<b>Model</b>	F5 Finisher (Ricoh SR500, NRG CFN101)	<b>Code</b>	<b>Model Name</b>	<b>Serial Number</b>
<b>Modified Article</b>	Caster - 50m	A512-22	CFN101	6253110001
<b>Reason for Modification</b>	To facilitate servicing	A512-17	SR500	A3563110001

**DETAILS OF MODIFICATION**

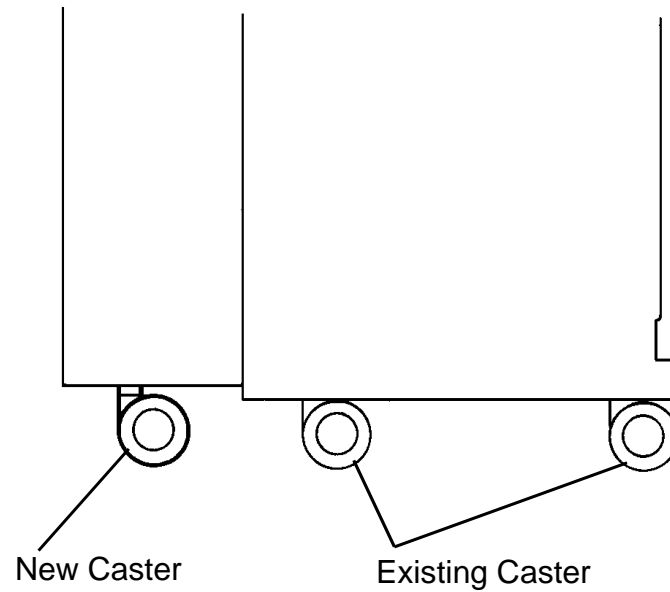
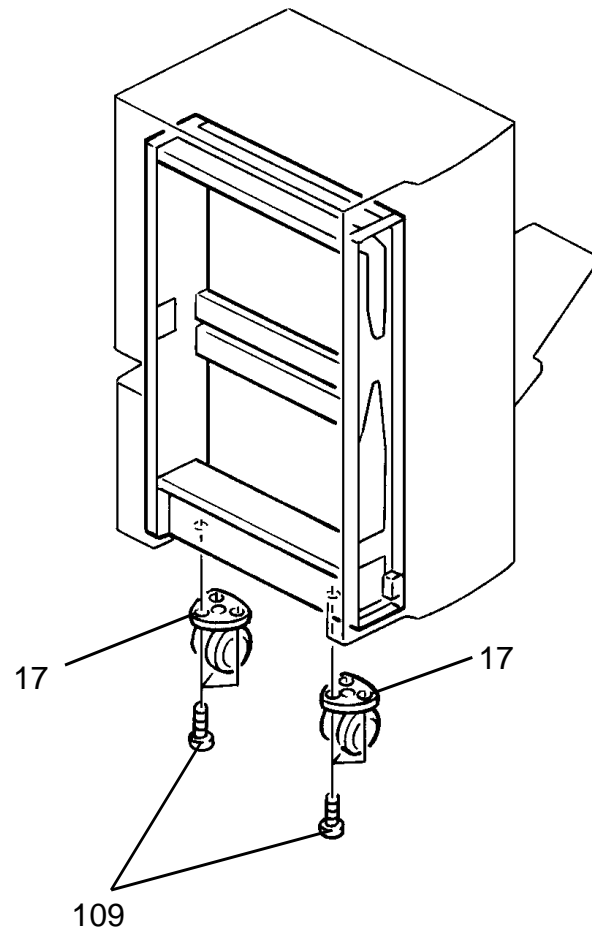
When the finisher is removed from the copier or LCT, it tends to be tilted. To prevent this, two casters have been added. ( Screw holes have been added in the fixing bracket of P/N-A5121120, but its part number remains the same.)

New P/N	Description	Q'ty	Parts Catalog	
			Index No.	Page
AH012006	Caster - 50m	4 → 6	35	* 17
03150080B	Philips Pan Head Screw - M5 x 8	n → n+6	35	* 109

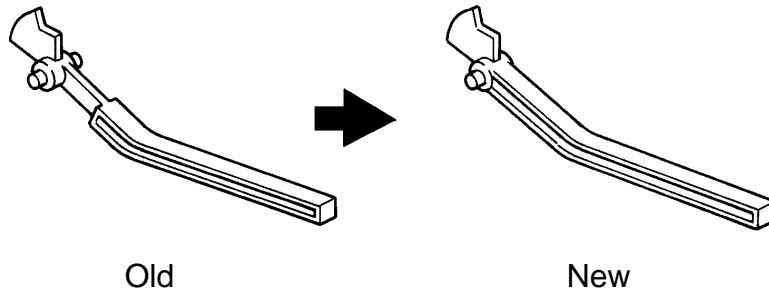
Due to part standardization with the finisher for F410/420, the following part has been changed.

P/N	New P/N	Description	Q'ty Used	Inter-changeability	Parts Catalog	
					Index No.	Page
A3533171	A3791225	Upper Sensor Actuator	1 → 1	O/O	19	19

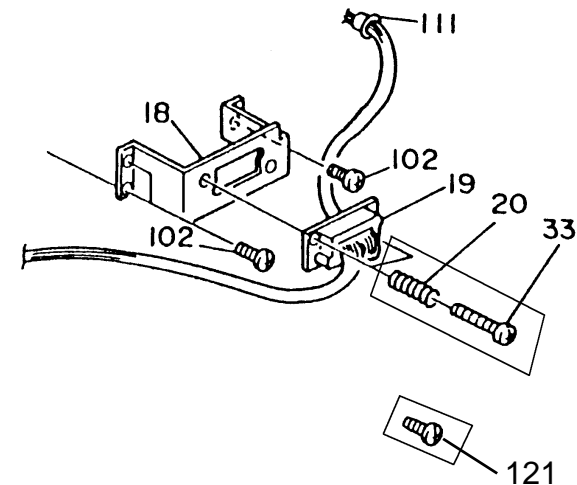
2. Correct the part list and illustration as follows:

Incorrect P/N	Correct P/N	Description	Q'ty Used	Parts Catalog	
				Index No.	Page
AA063068		Spring Connector	2 → 0	20	25
54465832		Connector Guide Pin	2 → 0	33	25
	03530080B	Screw - M3 x 8	0 → 2	* 121	25

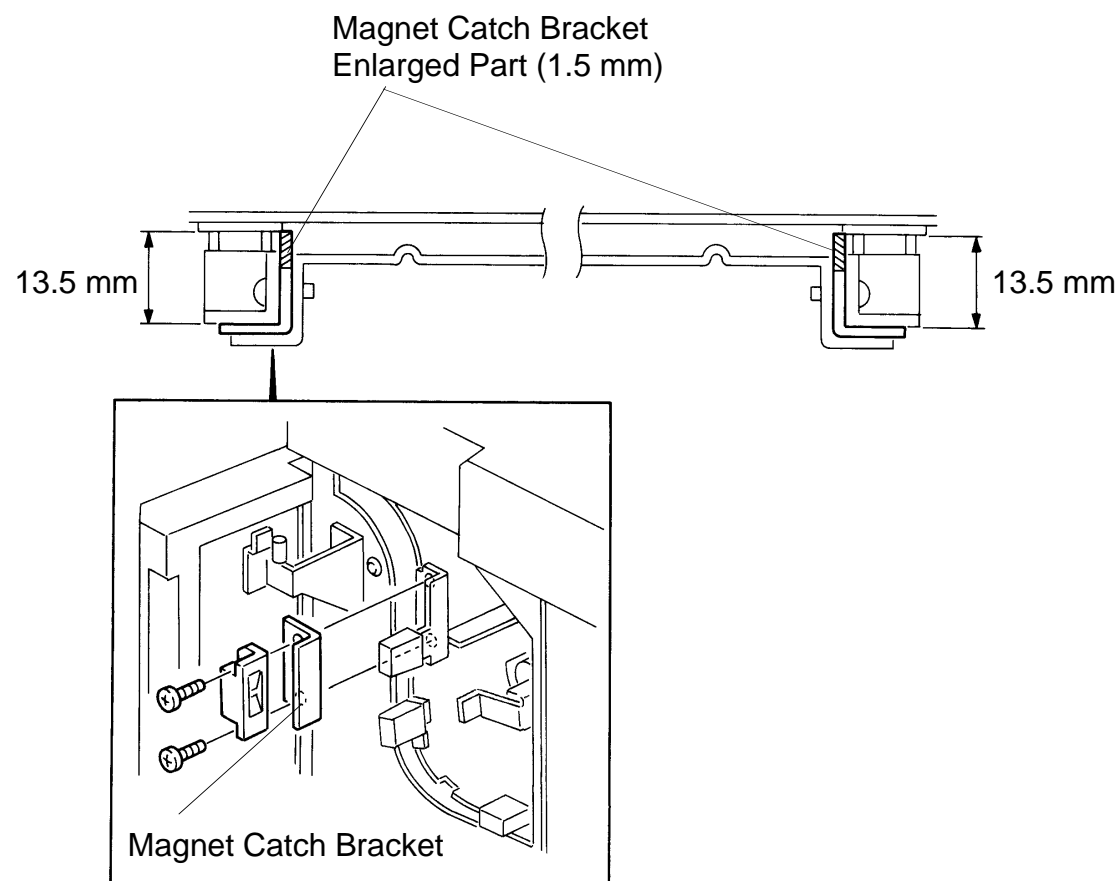
To ensure the clearance between the upper and lower entrance paper guide plates, the shape of the magnet catch bracket has been changed. For details, refer to RTB - 032.

NOTE: Four magnet catch brackets were used in this product, but only the two of the four for the entrance paper guide plates (as indicated below) have been changed to the new type. The other two remain the same.

Model		F5 Finisher (Ricoh SR500, NRG CFN101)						Code	Model Name	Serial Number	
Modified Article		Magnet Catch Bracket						A512 - 22	CFN101	6255010001	
Reason for Modification		To prevent paper jams at the finisher's entrance						A512 - 17	SR500	A3565010001	
								A512 - 27	SR500	From first production	
Draw No.	Old Parts No.		New Parts No.	Description	Rank	Q'ty Used Old→New	Inter-change-ability	Parts needed for replacement by new part		Parts Catalog	
								Part No.	Description	No.	Page
	A4612145	└─┐		Magnet Catch Bracket		2 → 0 2 → 2				9 9	27 29
			A5122113	Magnet Catch Bracket		0 → 2	X/O			9	27

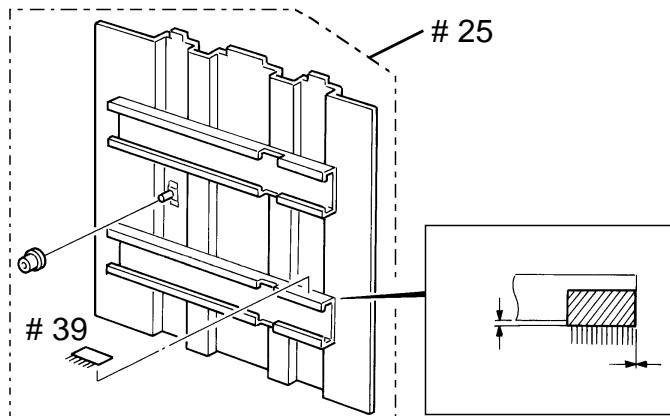
To prevent static electricity, an antistatic brush has been added on the end fence.

NOTE: When attaching the antistatic brush to the old end fence, the paint on its seat should be removed to ensure the grounding of the brush.

Old P/N	New P/N	Description	Q'ty Used	Inter-change-ability	Parts Catalog	
					Index No.	Page
A3533211	A3533020	End Fence	1 → 1	X/O	25	21
	A5562151	Antistatic Brush	0 → 1		* 39	21

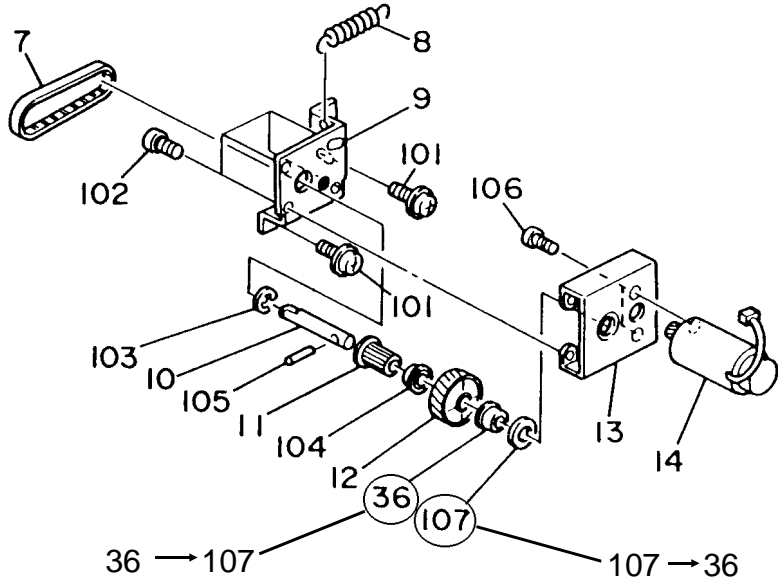
Please correct your parts catalog as follows:

\* Index number correction in the illustration  
Page 18      Index No. 36 → 107  
                                 107 → 36

Page 14 : Transport Unit

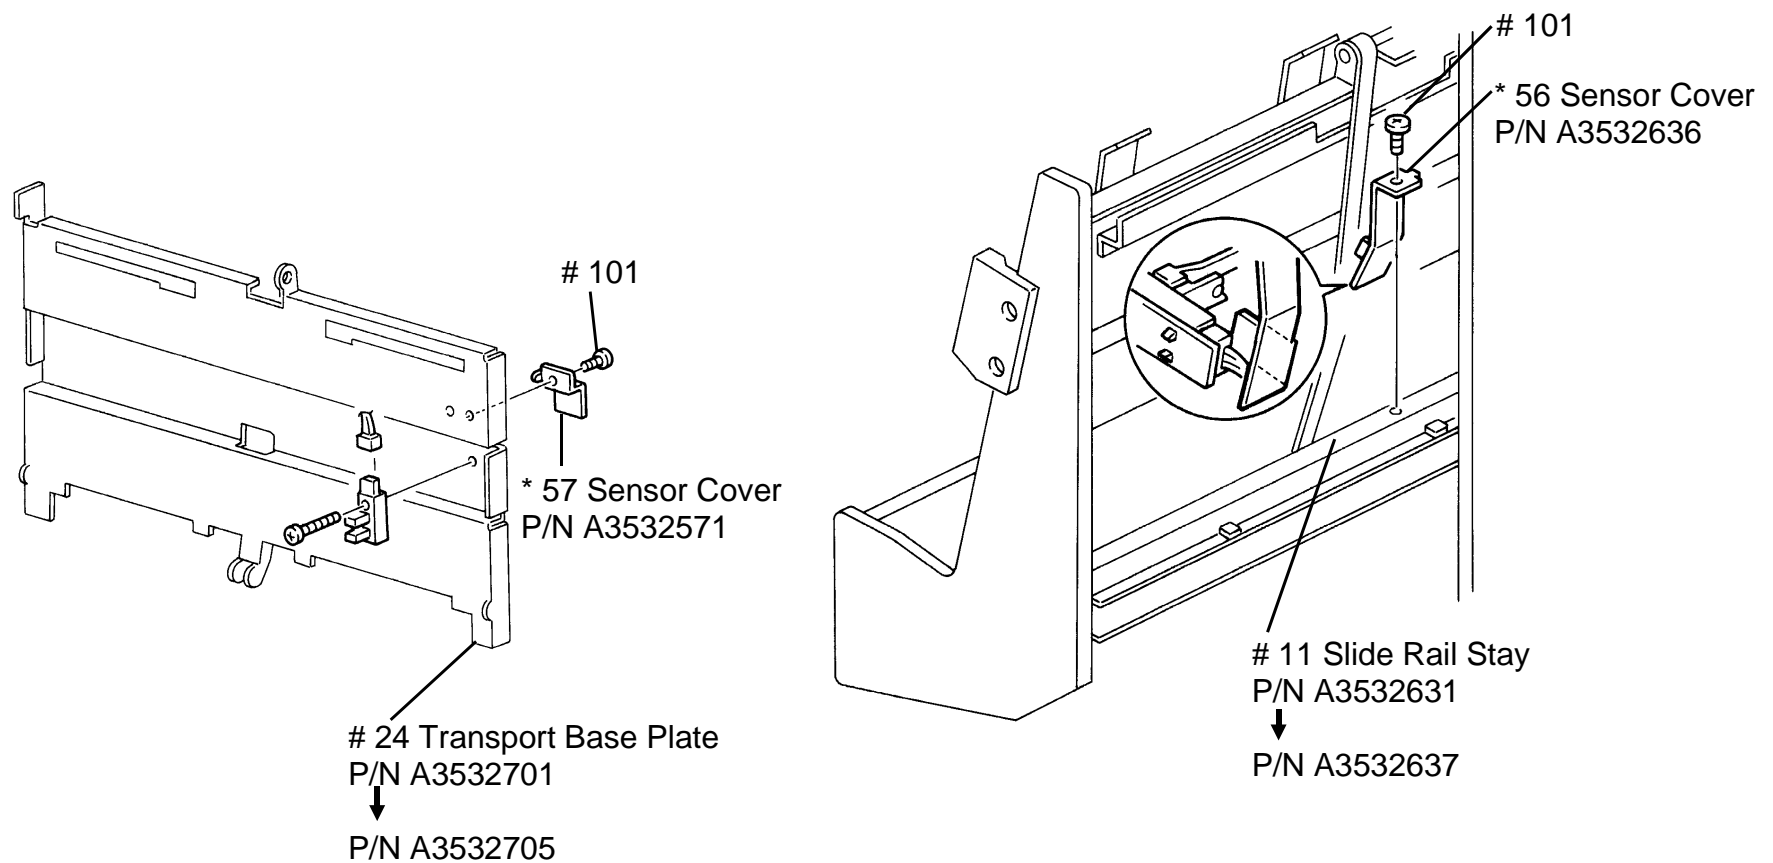
To meet the Conformité Européenne (CE) standards, the sensor covers have been added as shown.

Model			F5 Finisher (Ricoh SR500, NRG CFN101)						Volt/Hz	Date of Modification	Serial Number	
Modified Article			Finisher Main Board etc.						A512-22	CFN101	625603XXXX	
Reason for Modification			To meet the Conformité Européenne (CE) standards						A512-17	SR500	A3565090001	
									A512-27	DR500	A3565080001	
Draw No.	Old Parts No.		New Parts No.	Description	Rank	Q'ty Used Old→New	Inter-change-ability	Parts needed for replacement by new part		Parts Catalog		
								Part No.	Description	No.	Page	
	A3532631		A3532637	Slide Rail Stay		1 → 1	X/O			11	15	
			A3532636	Sensor Cover		0 → 1				* 55	15	
	A3532701		A3532705	Transport Base Plate		1 → 1				24	15	
			A3532571	Sensor Cover		0 → 1				* 56	15	
			03040060B	Philips Tapping Screw - M4 x 6		n → n+2				101	15	
	A5125110		A5125120	Finisher Main Board		1 → 1	X/O	(for Europe)		24 *	25 39	
	A5125110		A5125120	Finisher Main Board		1 → 1	O/O	(for other country)		24 *	25 39
